Access Compliance Report

Public Rights-of-Way

(Curb Ramps)

Intersection ID: 10041631	Main Street: WHITEHALL_PARK_DR	Cross Street: N/A	Location: S
ADA ID: 41D51007E6D4	Ramp Type: PerpDiag	Initial Pass/Fail: Fail	Overall Compliance: No
Codes/Mitigation Info/Possible Solution		Field Measurements/Component Compliance	
Severity Score: 21.25

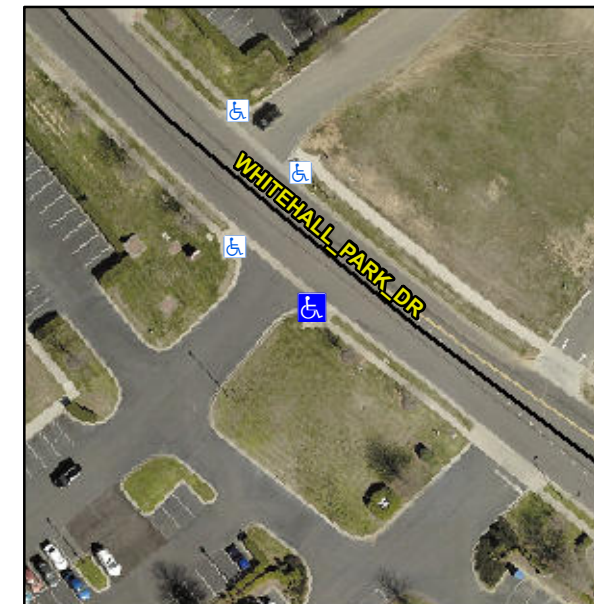
Remove & Replace Curb Ramp With Two New Directional Ramps or Equivalent.

R304.5.1, R304.2.2

Compliance	Description	Data	Compliance	Description	Data
N/A	Ramp Length (in)	47.0	No	Ramp Slope (%)	10.8
No	Ramp Width (in)	43.5	Yes	Ramp XSlope (%)	2.0
N/A	Flare Type LT	N/A	N/A	Flare Type RT	N/A
N/A	Flare Slope LT (%)	N/A	N/A	Flare Slope RT (%)	N/A
N/A	Flare Traversable LT?	N/A	N/A	Flare Traversable RT?	N/A
N/A	Landing Length (in)	N/A	N/A	DWS Provided?	N/A
N/A	Landing Width (in)	N/A	N/A	DWS Contrast?	N/A
N/A	Landing Slope (%)	N/A	N/A	DWS Length (in)	N/A
N/A	Landing X Slope (%)	N/A	N/A	DWS Full Width?	N/A
N/A	Landing Curb? (Y/N)	N/A	N/A	DWS Offset (in)	N/A
N/A	Shared Landing?	N/A			
N/A	Gutter Ponding?	N/A	N/A	Gutter Slope (%)	N/A
N/A	Gutter Lip Ht (in)	N/A	N/A	Gutter X Slope (%)	N/A
N/A	Painted X Walk1?	No	N/A	Painted X Walk2?	No
	X Walk 1 Direction	To NE		X Walk 2 Direction	To NW
N/A	X Walk 1 Width (in)	N/A	N/A	X Walk 2 Width (in)	N/A
	X Walk 1 Slope (%)	0.8		X Walk 2 Slope (%)	0.9
	X Walk 1 X Slope (%)	2.2		X Walk 2 X Slope (%)	1.1
